Addendum No. 2
August 17, 2021

Project: DGR Engineering
Lot 4, Block 19 Dawley Farm Village Addition
2932

Architect: Architecture Incorporated

5.10

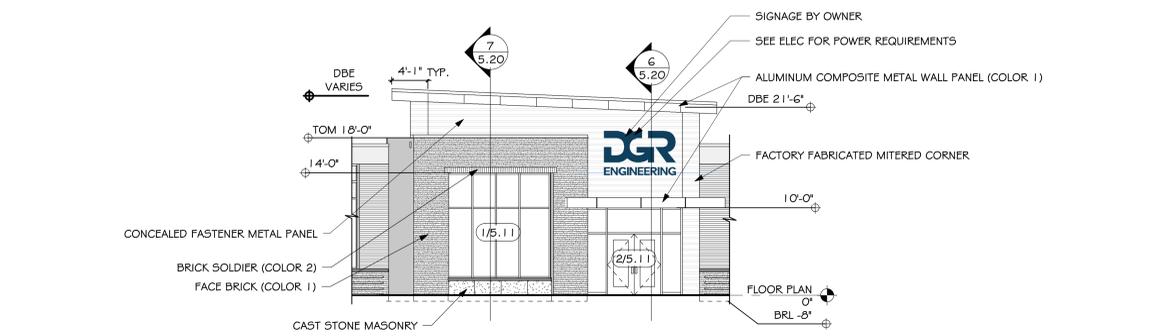
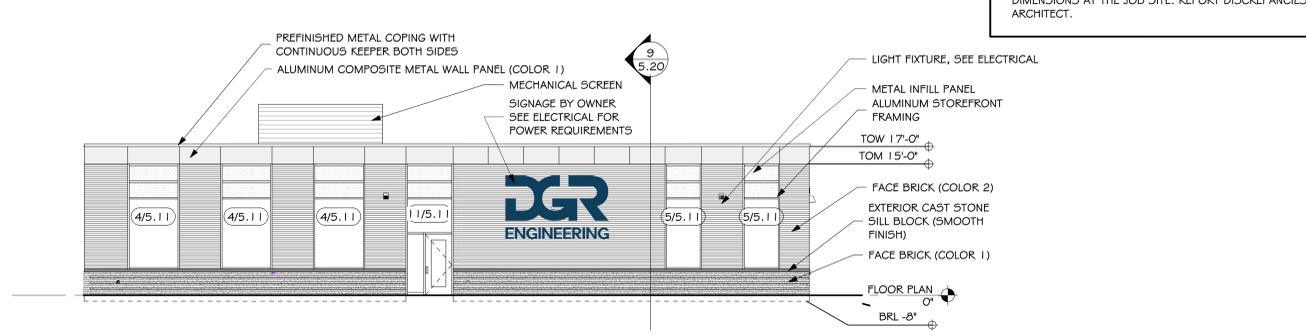
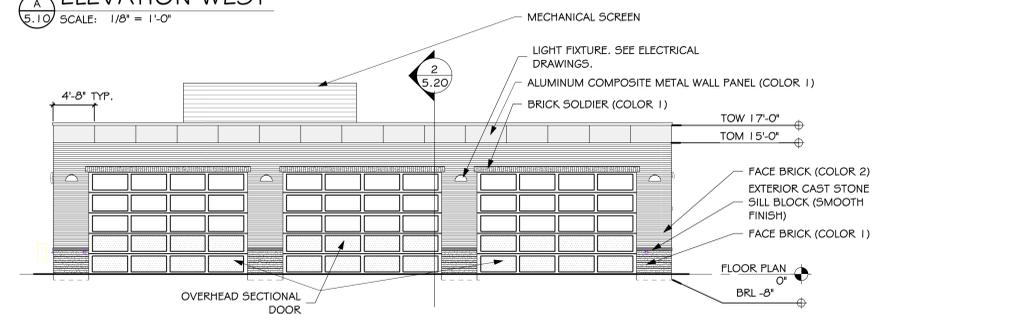
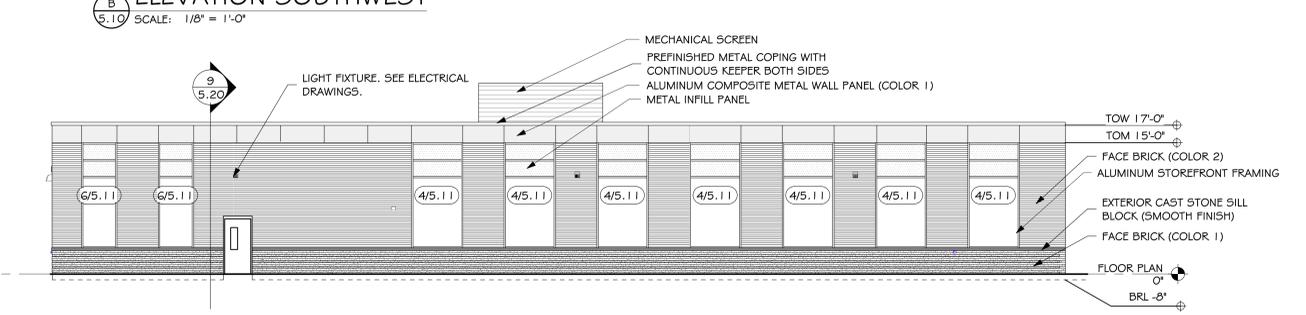
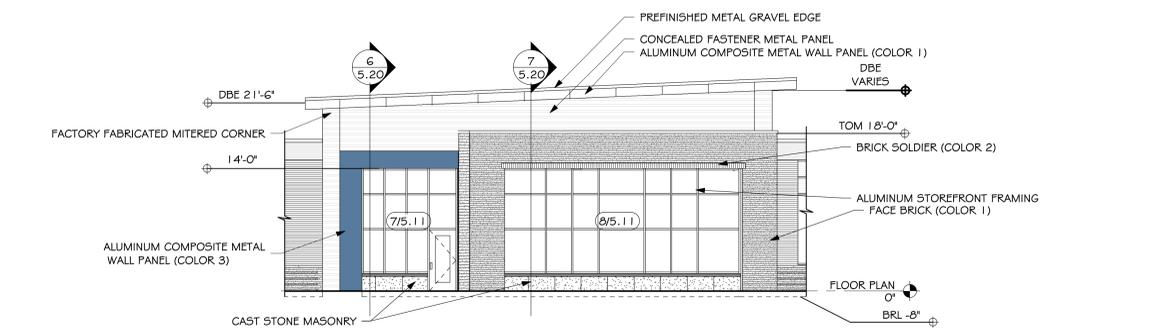
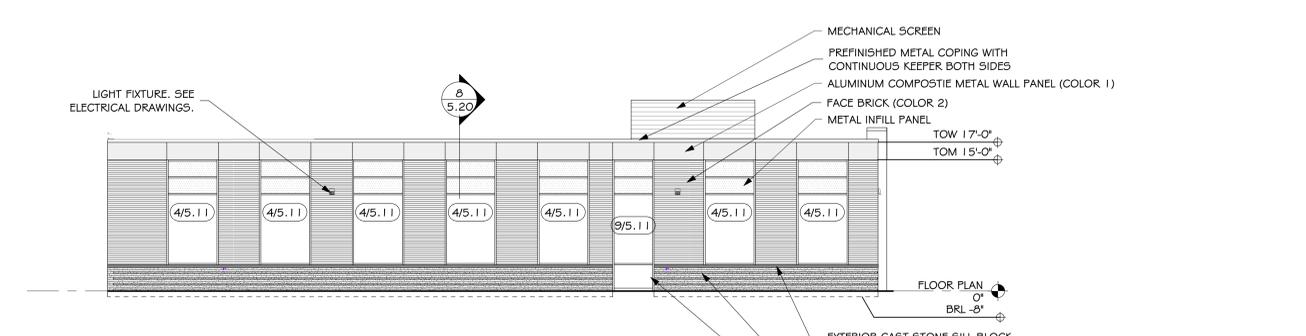
5) DRAWING 5.10 – EXTERIOR ELEVATIONS

- a) Reference revised exterior elevations for ACM Wall Panel joint locations.
- b) Reference Specification Section 108213 Rooftop Equipment Screens for locations noted ‘Mechanical Screen’ on elevations.

8.20

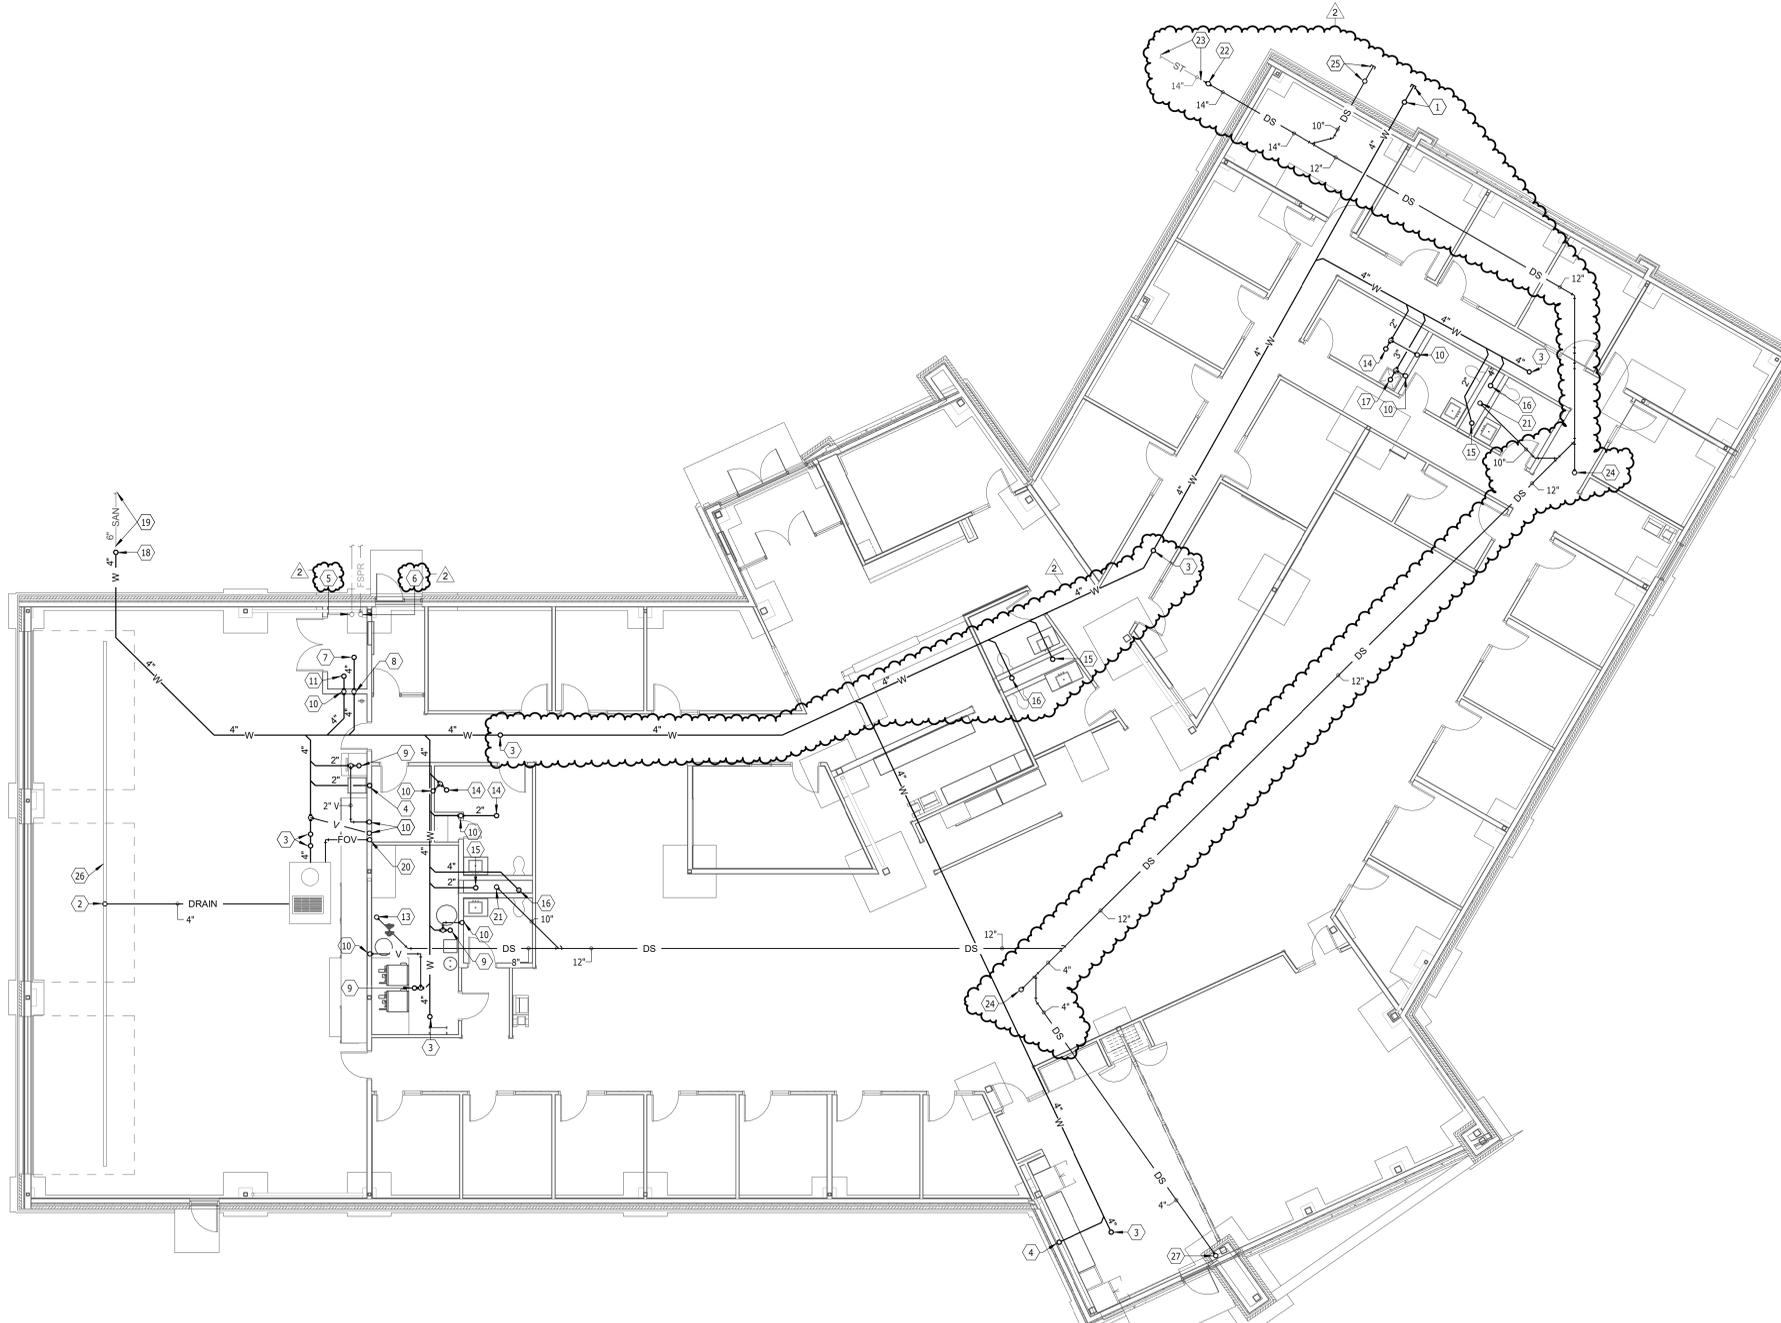
- b) FAN POWERED VAV TERMINAL SCHEDULE – Add FP-106 to schedule.
- 3) DRAWING 8.20 – UNDERGROUND PLAN – PLUMBING
 - a) Revise W & DS routing in several locations to provide increased clearance from nearby parallel footings.

- b) Revise keynotes for domestic water and fire protection piping coming into the building to emphasize the extensive coordination required between the plumber and site utility contractor regarding connection location, extent of work by each party, etc.

8.21

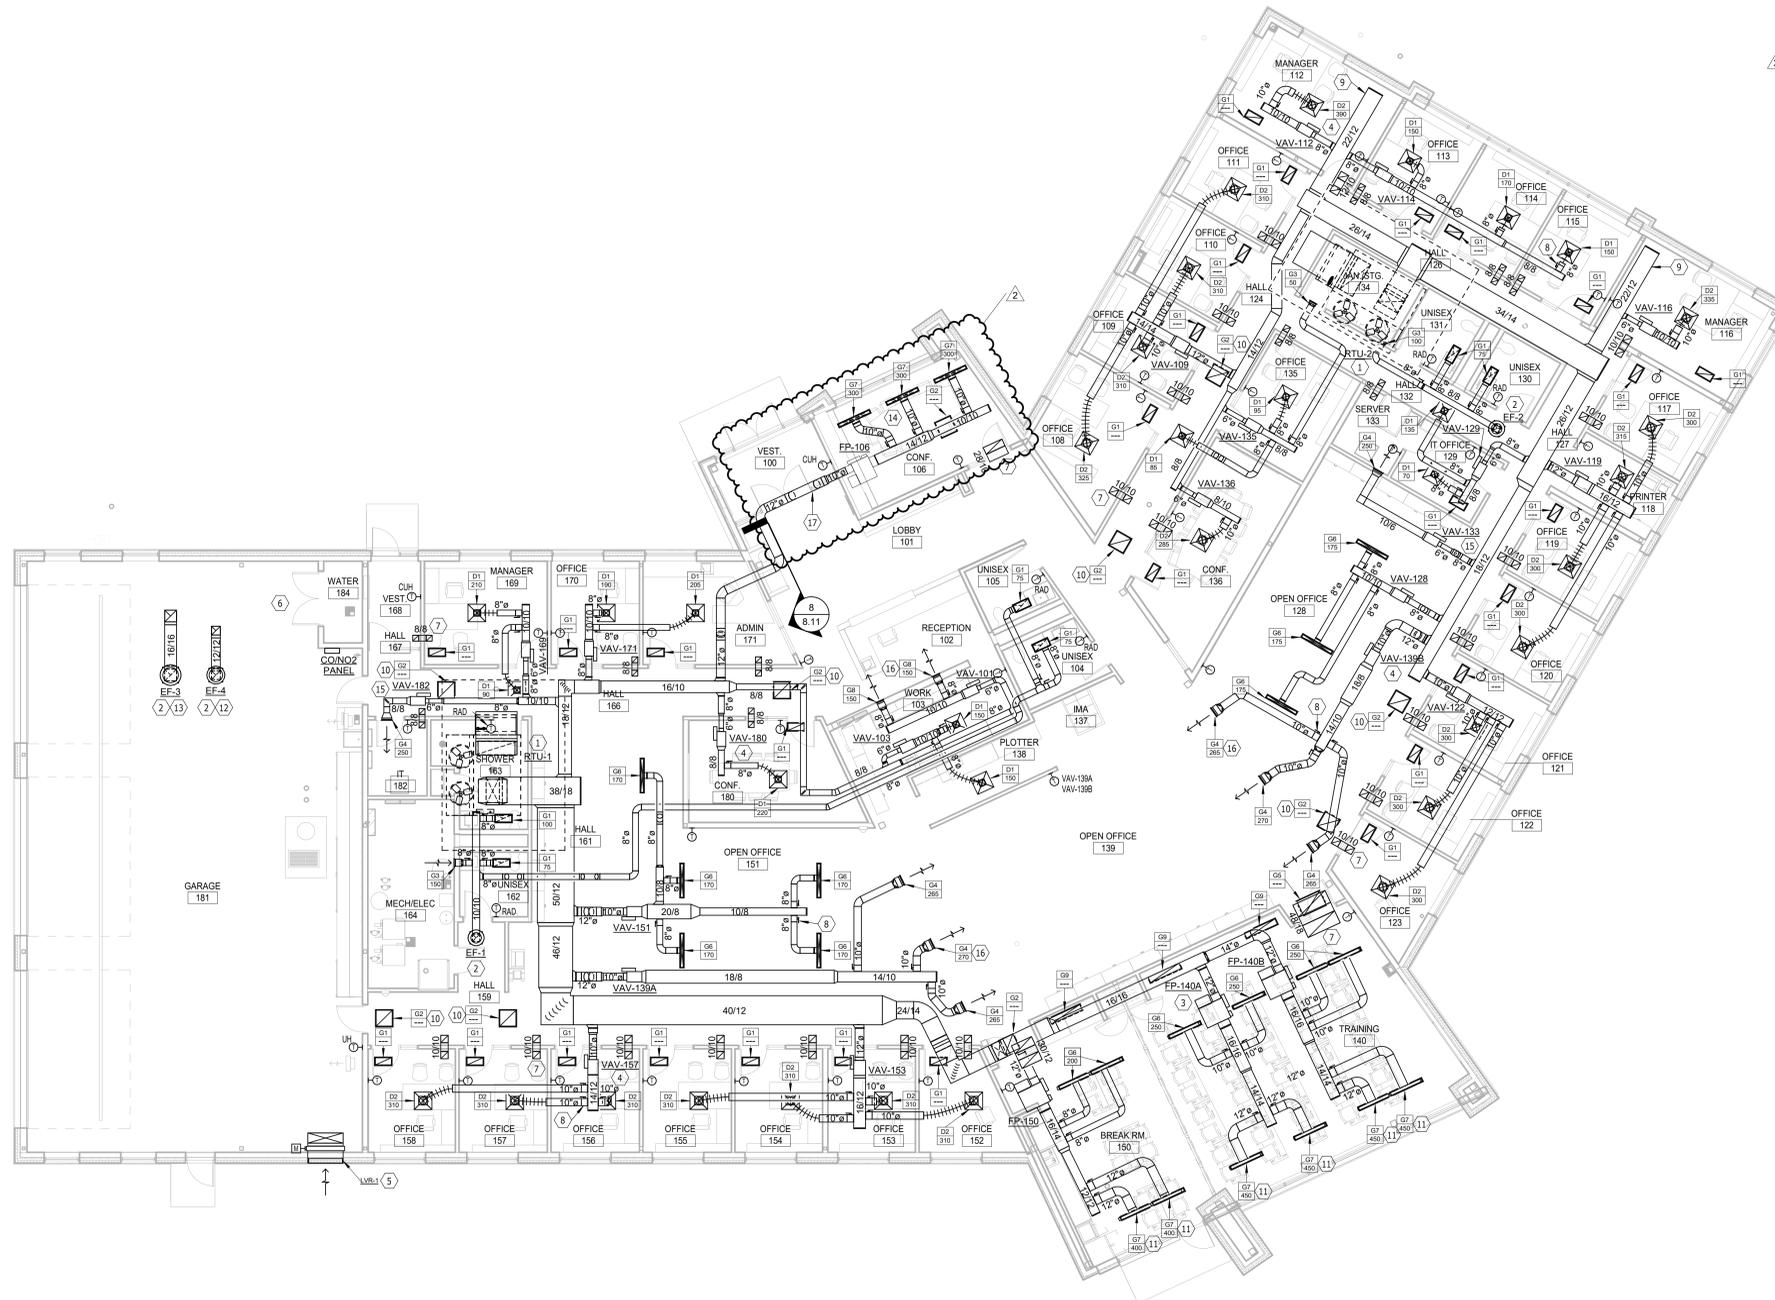
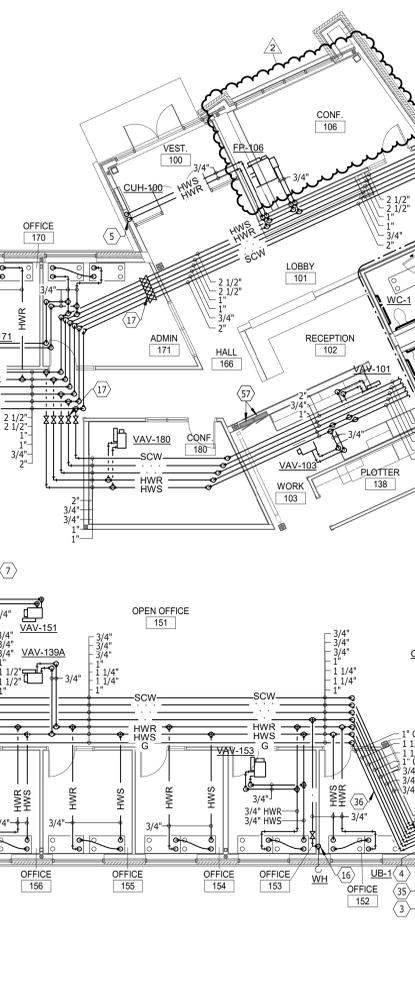
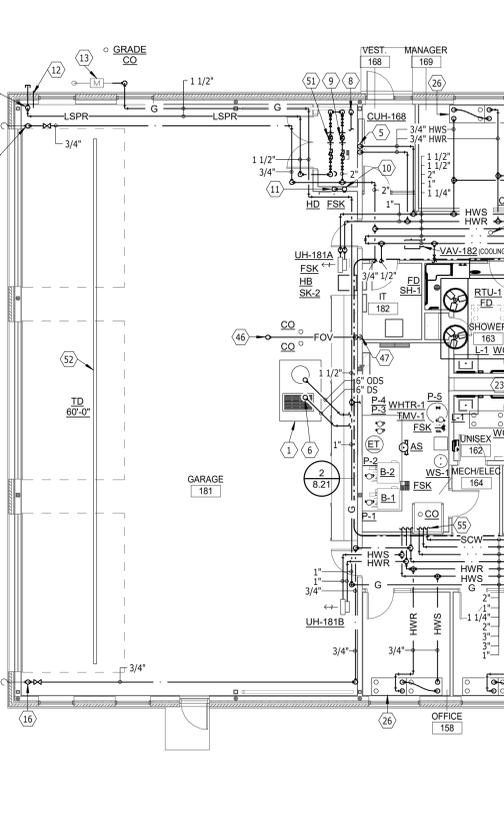
- 4) DRAWING 8.21 – FIRST FLOOR PLAN – PLUMBING & HEATING
 - a) Revise the location of the CW & HW piping for SH-1 in “Shower 163”.
 - b) Remove RCP’s in “Conf 106”. Revise piping connections to accommodate new FP-106.
